This software updates or alters the functions and features noted below. The instructions and information that follow are meant as a supplement to the original instruction manual that accompanied the FX-36 transmitter. Please refer to the original instruction manual where applicable, but replace the steps indicated below with these instructions. Please check to ensure that the update has been installed.

## V3.11

## V3.10

## V3.9

## Link is required when a new model is made from a model selection.

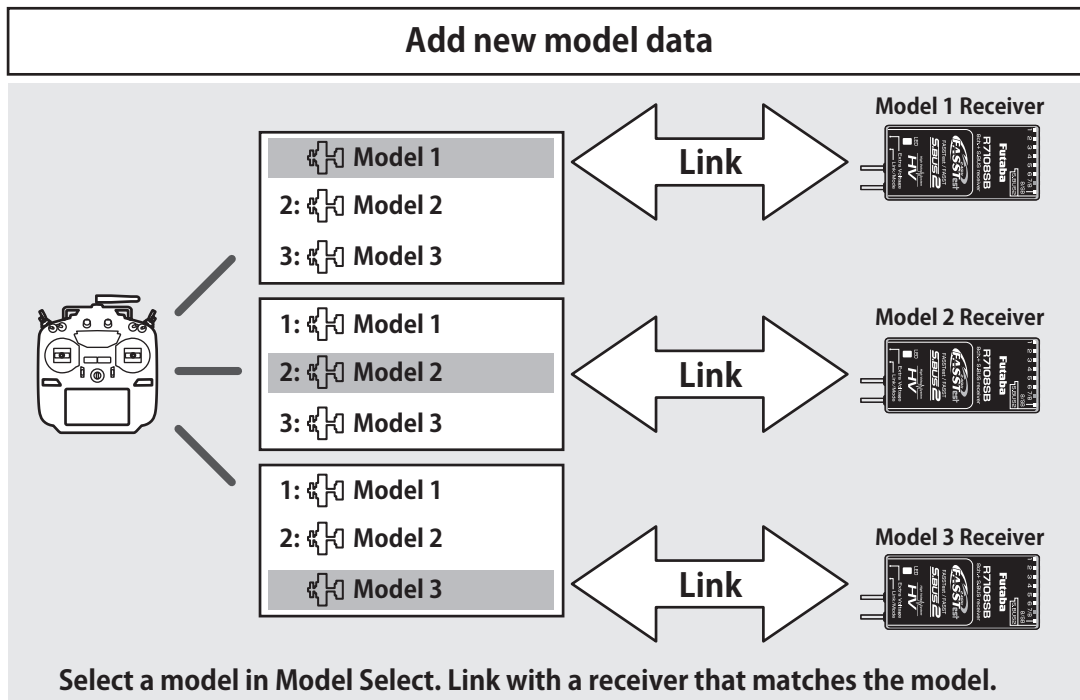
## 1. Add Model ID

As an added level of safety in the form of Model ID, which will prevent the accidental control of a model when using a different model data by preventing link.

■ In the system types (FASSTest, T-FHSS) compatible with the model ID function, a unique ID number (model ID) is set to each model data. Linking with a receiver stores the model ID of the model data in that receiver. The receiver operates only when it receives radio waves transmitted using model data that matches the stored model ID. As a result, the receiver does not operate even if model data of an unintended setting is used by mistake, so it is possible to prevent a malfunction due to a model selection mistake.

- If you want to use different model data from the model data that you have been using, link again.
- Model ID feature is enabled only if the system type is FASSTest or T-FHSS. Please note that model ID function can not be used on other systems.
- For safety reasons, model ID function can not be disabled.
- Model ID is automatically set when copying or adding model data.

### **When using R3004SB**

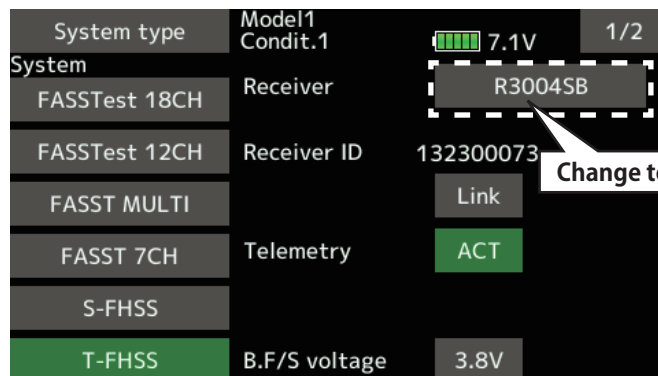
■ When using the **R3004SB**, set "Receiver" in the system type screen T-FHSS mode setting to [R3004SB]. When using other T-FHSS compatible receivers, set "Receiver" to [Normal].

R3004SB receiver does not support model ID function.

### ◆ How to display the Airspeed sensor screen.

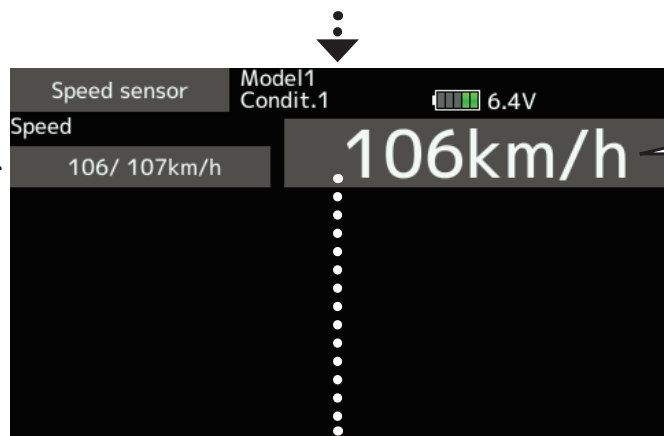
- ① [Linkage menu] → [Telemetry]

- ② Tap [Speed sensor]

## ◆ Alarm setting

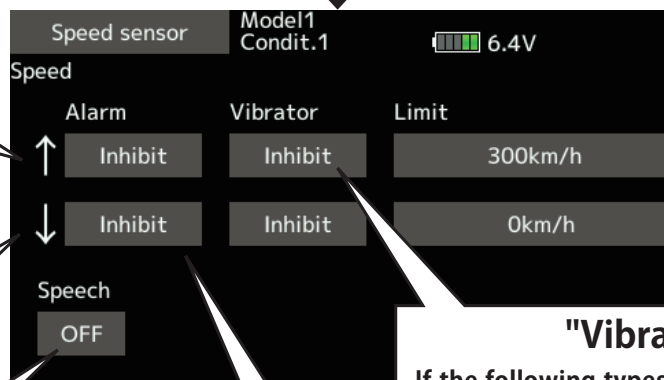
↑ An upward arrow indicates the alarm will sound when the speed reaches above your set value.

↓ A downward arrow indicates the alarm will sound when the speed reaches below your set value.

The ON/OFF switch of Speech is chosen.

A setup of the speed on which the alarm operates.

### "Vibrator" type

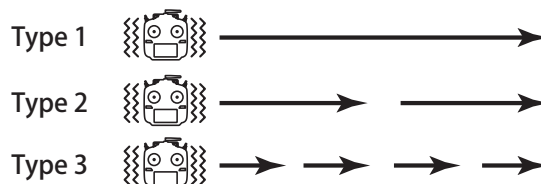
If the following types are selected, the transmitter will vibrate during the warning.

## 2. CRSF Protocol for TBS

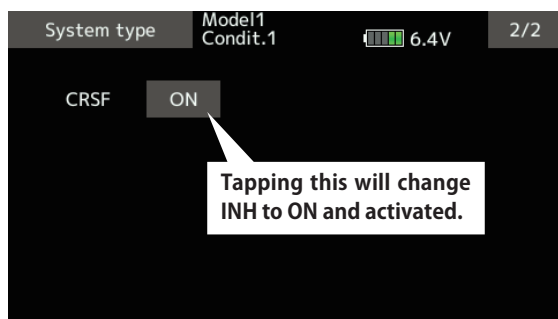
The T18SZ/T16SZ/FX-36 has been made compatible with the CRSF (TBS) protocol.

- ① [Linkage menu] → [System Type] → [Page 2/2] is opened from the transmitter.

- ② Tap the "CRSF" button to [ON]. A signal conforming to the CRSF standard is output from the S.BUS setting connector (S.I/F) of the transmitter.

- When using CRSF, the S.BUS servo setting function and [Reload] [Register] [Change slot] functions cannot be used. When setting S.BUS servo and sensor, set CRSF to INH.
